MEMORANDUM

**UMC TIA # 007-18
Final Ballot Results**

UNIFORM MECHANICAL CODE TIA FORM - 2018

Submitter Name: Julius Ballanco, P.E.
Company: JB Engineering and Code Consulting, P.C. representing Daikin U.S.
Address: 1661 Cardinal Drive, Munster, IN 46321
Phone number: 219-922-6171

FIGURE 1106.13.11.4

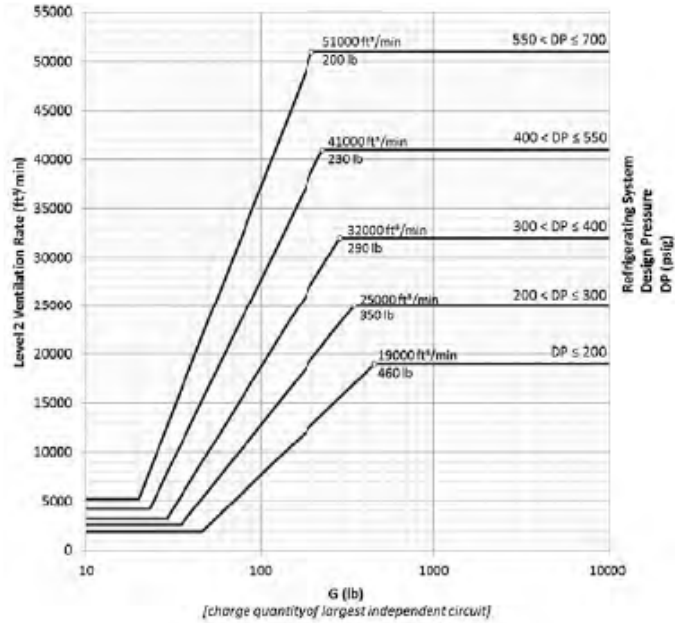
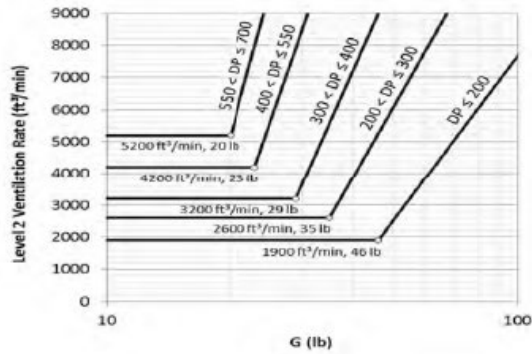
1106.13.11.4 Safety Group A2L, B2L Other than Ammonia. When required by Section 1106.13.11.3, the total airflow for Level 2 Ventilation shall be not less than the airflow rate determined by Figure 1106.13.11.4. [ASHRAE 15:8.13.11.4]

LEVEL 2 VENTILATION RATE FOR CLASS 2L REFRIGERANTS
[ASHRAE 15: FIGURE 8.13.11.4-1]
